Access Compliance Report

Public Rights-of-Way

(Curb Ramps)

Intersection ID: 10033959	Main Street: PARK_RD	Cross Street: N/A	Location: NE
ADA ID: 8BB8A8F47256	Ramp Type: PerpDiag	Initial Pass/Fail: Fail	Overall Compliance: No
		Severity Score: 25

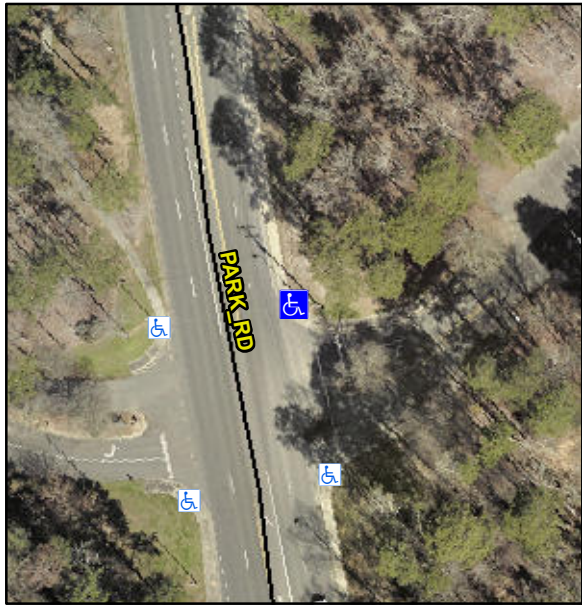
Codes/Mitigation Info/Possible Solution			Field Measurements/Component Compliance					
	Possible Solutions:		Compliance	Description	Data	Compliance	Description	Data
	Remove & Replace Curb Ramp With Two New Directional Ramps or Equivalent.		N/A	Ramp Length (in)	59.0	No	Ramp Slope (%)	8.6
			Yes	Ramp Width (in)	48.0	No	Ramp XSlope (%)	6.9
			N/A	Flare Type LT	N/A	N/A	Flare Type RT	N/A
			N/A	Flare Slope LT (%)	N/A	N/A	Flare Slope RT (%)	N/A
			N/A	Flare Traversable LT?	N/A	N/A	Flare Traversable RT?	N/A
			N/A	Landing Length (in)	N/A	N/A	DWS Provided?	N/A
			N/A	Landing Width (in)	N/A	N/A	DWS Contrast?	N/A
			N/A	Landing Slope (%)	N/A	N/A	DWS Length (in)	N/A
			N/A	Landing X Slope (%)	N/A	N/A	DWS Full Width?	N/A
			N/A	Landing Curb? (Y/N)	N/A	N/A	DWS Offset (in)	N/A
			N/A	Shared Landing?	N/A			
			N/A	Gutter Ponding?	N/A	N/A	Gutter Slope (%)	N/A
			N/A	Gutter Lip Ht (in)	N/A	N/A	Gutter X Slope (%)	N/A
			N/A	Painted X Walk1?	No	N/A	Painted X Walk2?	No

X Walk 1 Direction	To W		X Walk 2 Direction	To S
			N/A	X Walk 1 Width (in)	N/A	N/A	X Walk 2 Width (in)	N/A
				X Walk 1 Slope (%)	0.5		X Walk 2 Slope (%)	0.4
				X Walk 1 X Slope (%)	2.2		X Walk 2 X Slope (%)	1.2
			N/A	Ramp inside XWalk1?	N/A	N/A	Ramp inside XWalk2?	N/A
			Road Slope (%)	1.5	N/A	Clear Space?	N/A	
			Road X Slope (%)	1.3	N/A	Clear Space to XWalk (in)	N/A	
		N/A	Any Obstructions?	N/A	N/A	Storm Grate/Utility Hazard?	N/A	
			Obstruction Type			Storm Grate/Utility Type		
					N/A		N/A	
					Yes	Surface Condition? (G/P)	Good	
Street 1 Name		PARK RD						
Stop Condition-Street 2		None						
Street 2 Name		ENTRANCE						
Stop Condition-Street 1		StopSign						
Total Cost:		\$ 3200.00
